Technical Report - Supporting Data and Analysis for Skagit River RFIS Appeal

**City of Burlington
City of Mount Vernon
City of Sedro-Woolley
Town of La Conner**

Skagit County, Washington

Pacific International Engineering, PLLC

Figure 25. Cell Ground Elevation Difference between PIE Revised and COE Original FLO-2D Model

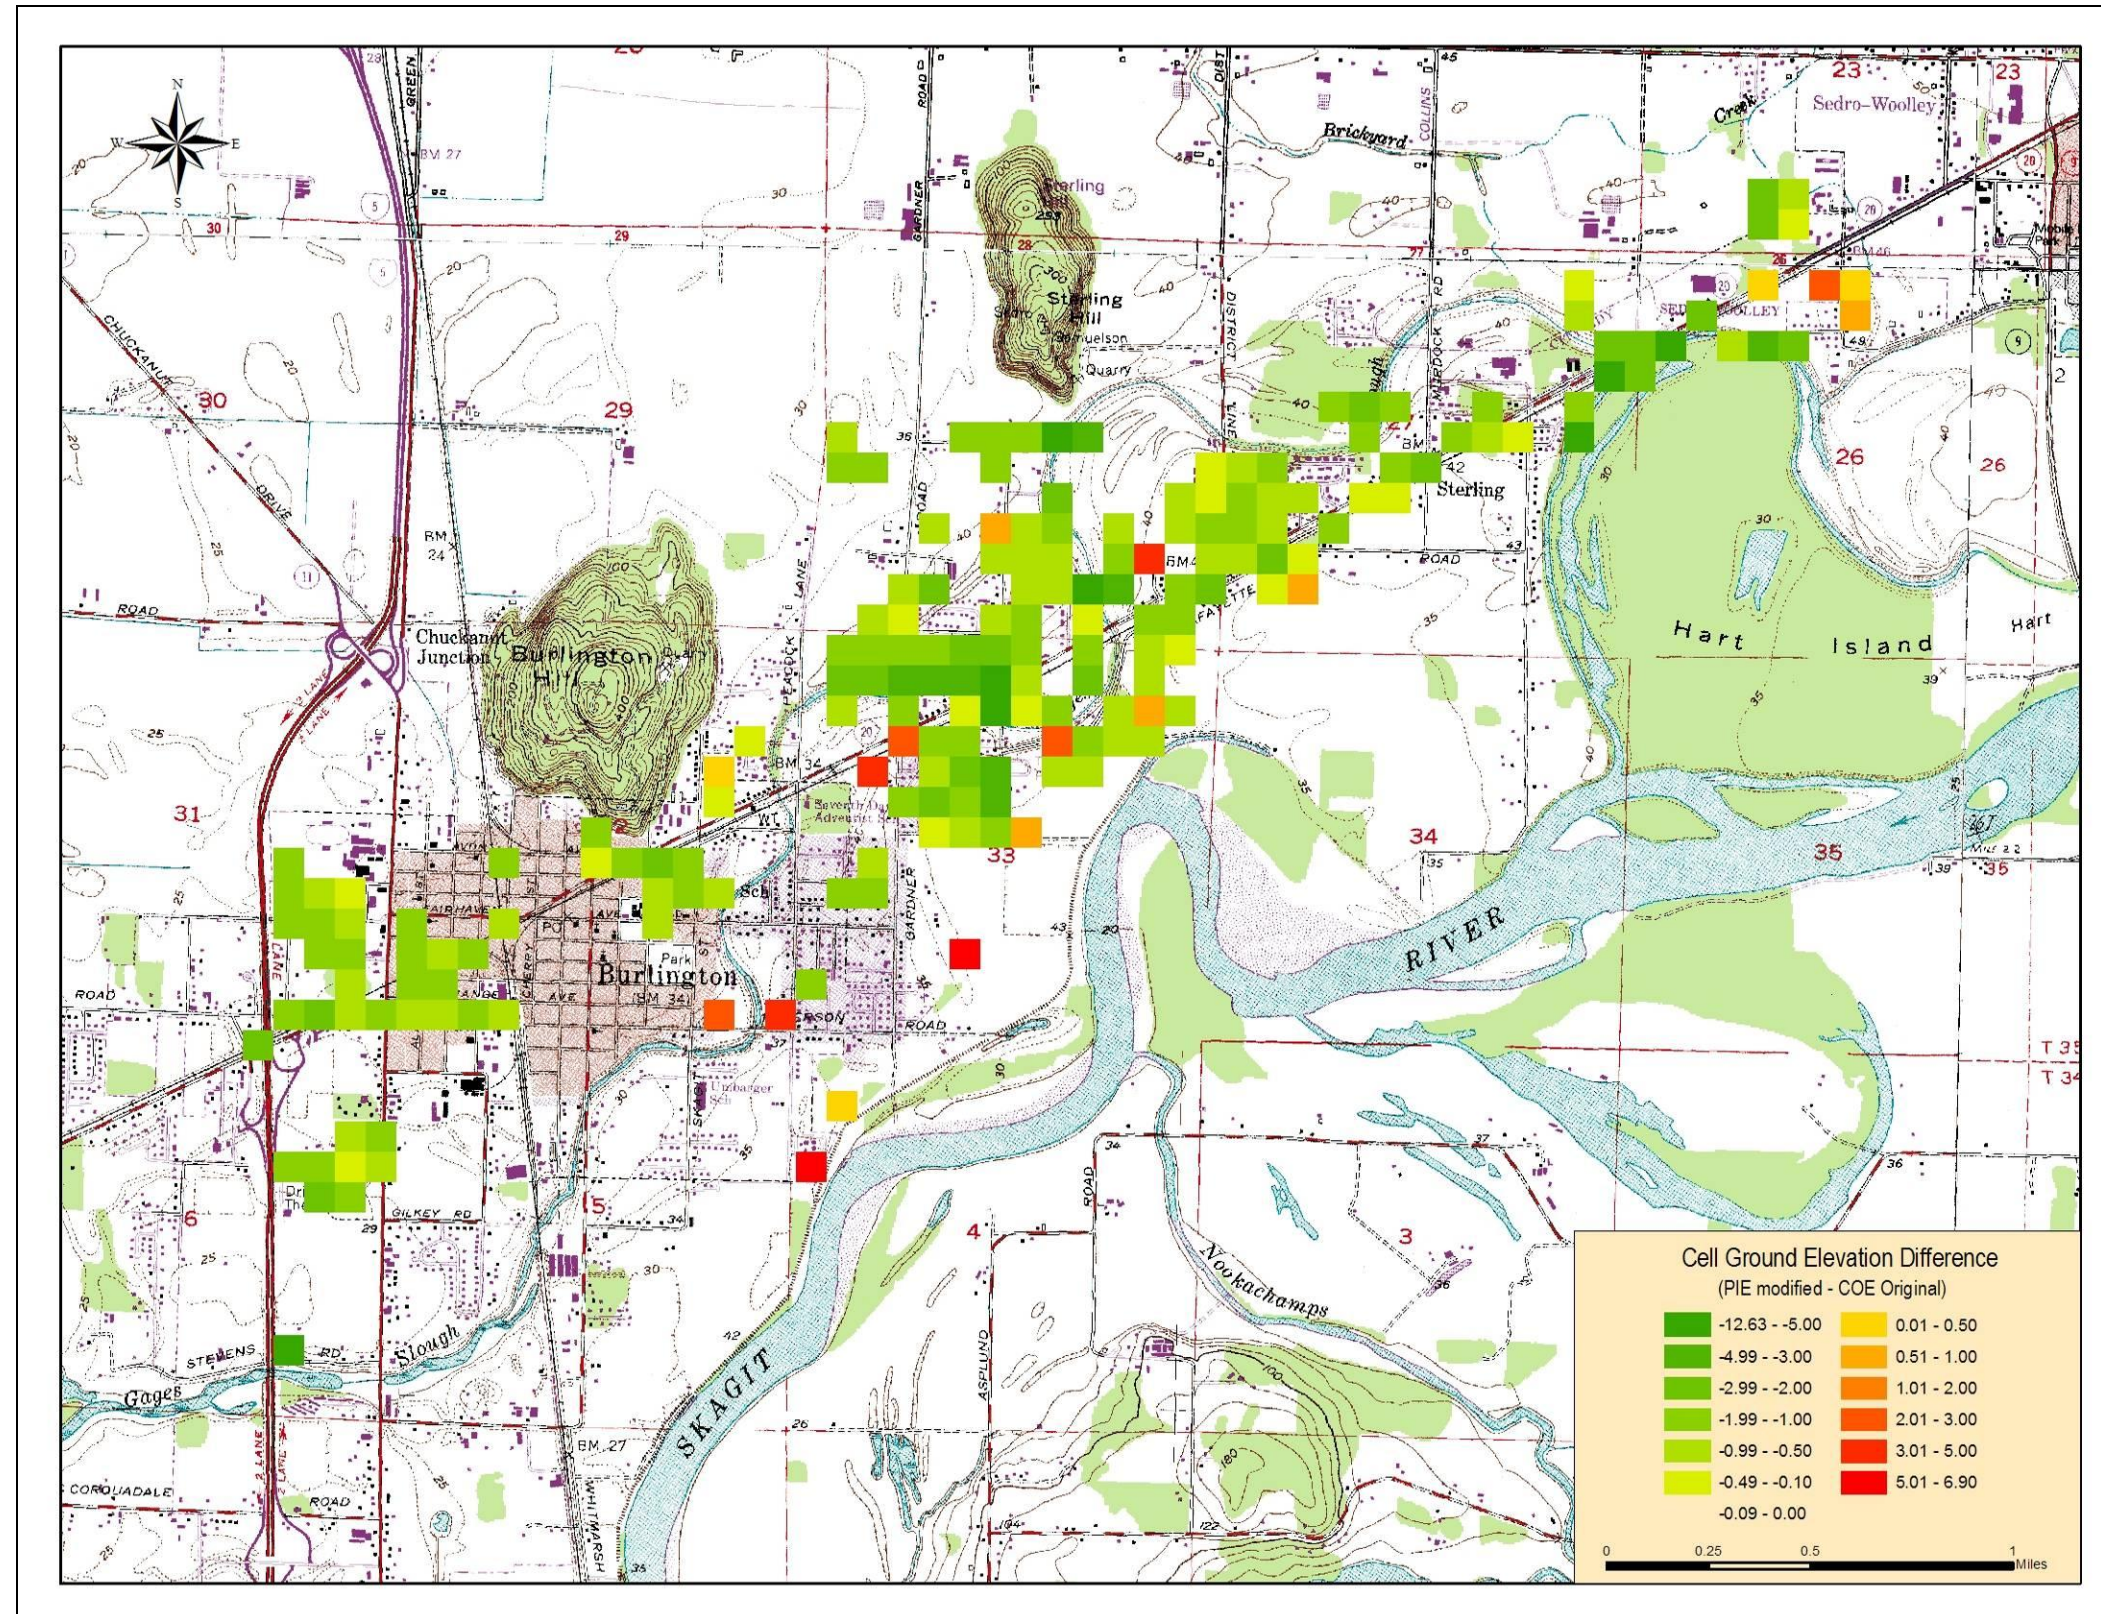
- (5) Revising the grid cell ground elevations as indicated in Figure 25 which shows the cell ground elevation difference between our revised model and the COE original model.
